As of October 1980, the modified screw plug M 38 x 1.5 is installed together with an O-ring.

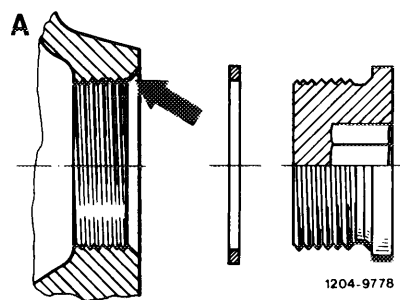
The chamfer in the crankcase was changed for this reason (2nd version).

When installing a coolant preheater, an O-ring or sealing ring to suit the chamfer in the crankcase should be used.
